Interactive comment on “Measuring hydrodynamics and sediment transport processes in the Dee estuary” by R. Bolaños and A. Souza

Review of *essdd-3-79-2010* : Measuring hydrodynamics and sediment transport processes in the Dee estuary R. Bolanos and A. Souza General comments The topic is interesting and the paper is well organized. Anyway I believe that few, minor, revisions should be considered before publishing the manuscript. Here follows my observations and suggestions to the authors:

Fig. 1. New figure 3

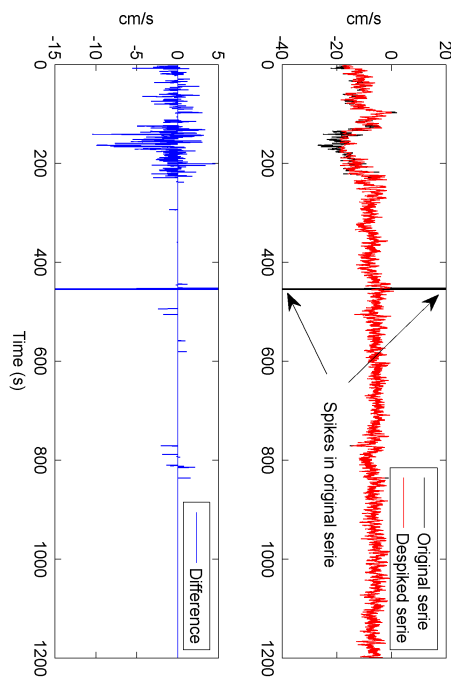
Figure 3 I cannot see any change between original and despiked data after then ordinal

2000. The plot is not clear enough, you may consider to add a plot of differences between original and despiked data, also adding a panel to the figure. Explicit “Hs”. What exactly means : “Number of Data “ (X-axis label)? AUTHORS: The data represents an intruburst time series (20 minutes of continuous record with an sampling frequency of 8 Hz), we have changed the figure to add a difference time series between the original and despiked and change the x axis to show the time in seconds. The time series shows the magnitude of the mean current with the turbulence variations. ADV data can present some spikes (such as the one with velocities larger than 30 cm and lower than -30) and thus the method aims to remove such spikes without removing the turbulence information. The fact that not many changes are observed between original and despiked means that the data is clean. We have also change the figure caption to make it clearer.

Section 4, row 2-4 (pag 86) You write : “Figure 3 shows an example of the despiking algorithm on the data. It can be seen that the method properly removes the spikes.

It has to be noted that the data was very clean and only a few spikes were found in the raw data.” It seems to me that the dataset shown in figure 3 is not “very clean”. It seems also that the despiking procedure works only in the first part of the window (from zero to about 2000). AUTHORS:As said before the data comes from a high frequency sampling and thus turbulence data is included, the method removes the spikes (eg. the one above and below -20 and 20 cm/s), the “noise” of the series is the turbulence associated fluctuations.

Fig. 2. New figure 5

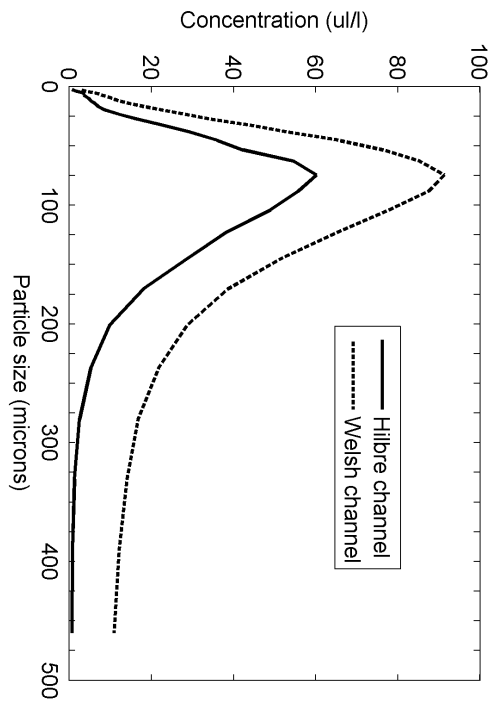
Figure 5 You should inform the reader explicitly about the vertical axis meaning. Also you should add minor ticks to the horizontal axis, i.e. each 25 units AUTHORS: The figure has been improved

Fig. 3. New figure 7

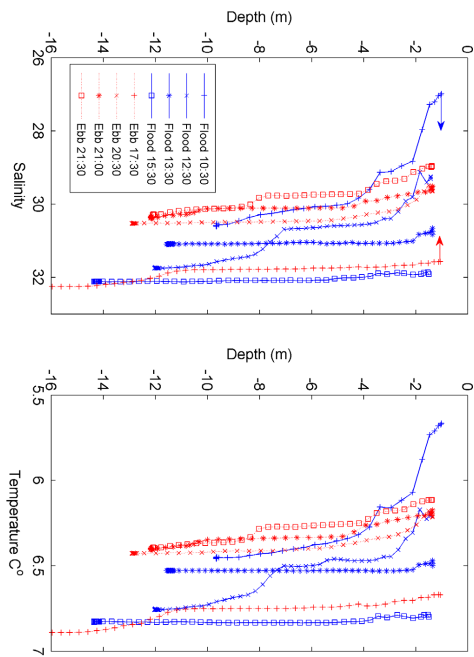
Figure 6 Salinity and Temperature profiles are so similar !? The figure is hardly readable, you should find another way to represent these data, perhaps with a multiple panel figure grouping flood/ebb events, so the comparison might be easier. Also T/S plots might be added. AUTHORS: Regarding figure 7 (the reviewer named it as figure 6), it shows clearly the time evolution of the profiles, at the start of the flood (just after low slack water) the water column is stratified, but as the flood starts to progress the water column mixes, and with the ebb tides the water stratifies again. By looking at the

changes in temperature and salinity it can be seen that the density is mainly controlled by salinity. We have explained this more clearly in the text and modified the figure.
